DATE: June 25, 2026  
TO: Potential Respondents  
FROM: Carrie Stoeckert—Construction Contract Expeditor III  
SUBJECT: Questions #1  
RFQ769-26-1023CS College of Music Building-Phase 1

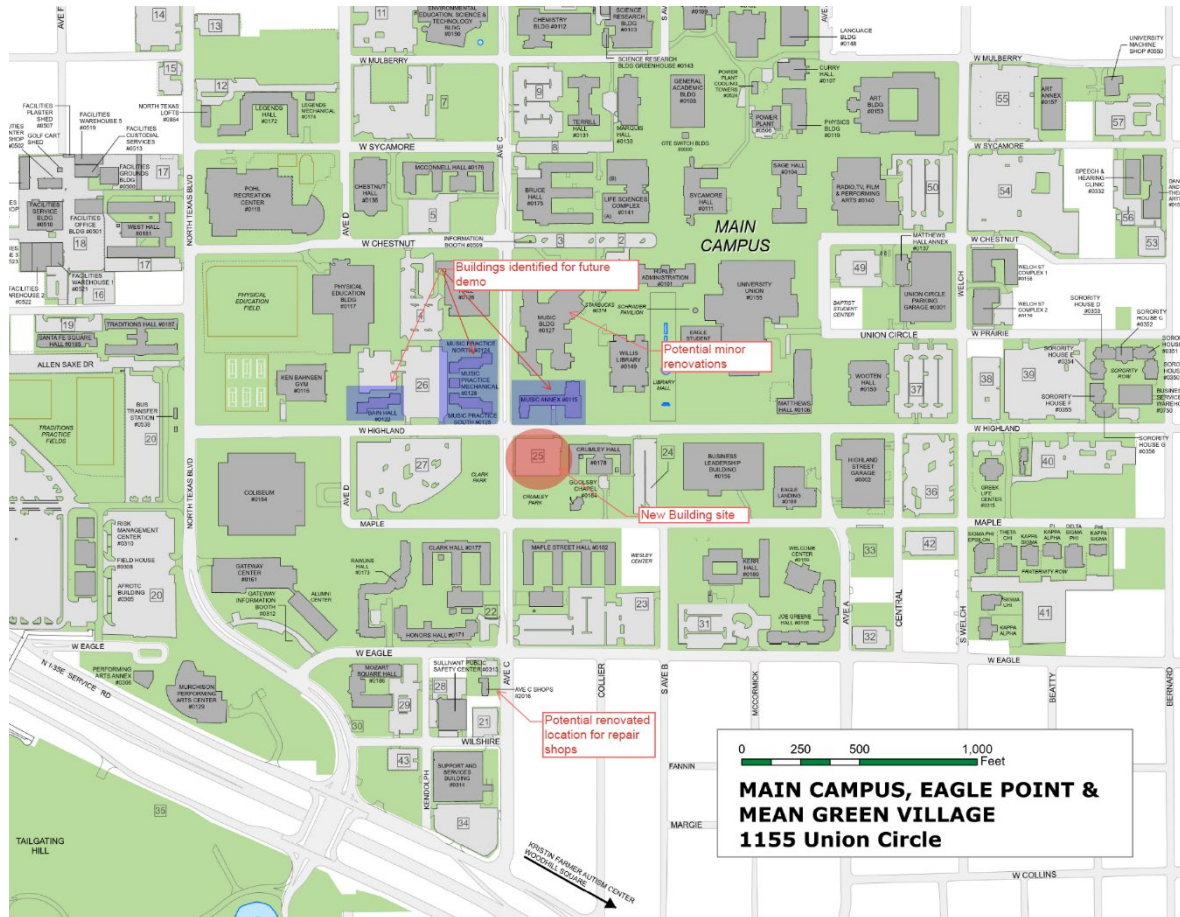
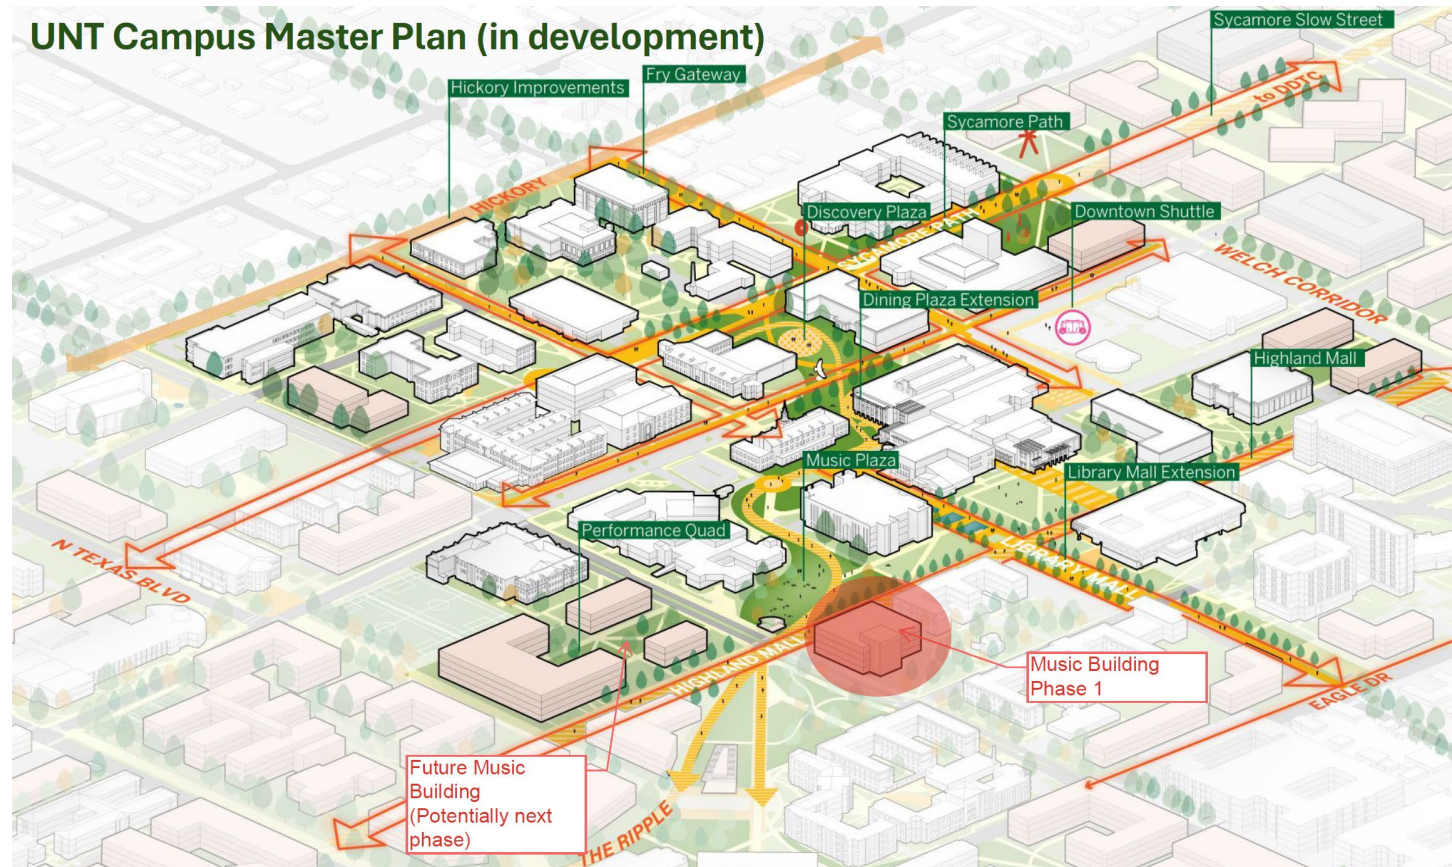
### 5. Project Site. Can you share the project site?

ANSWER: Existing campus map and campus master plan map (still in development) to assist with project scope and context below.
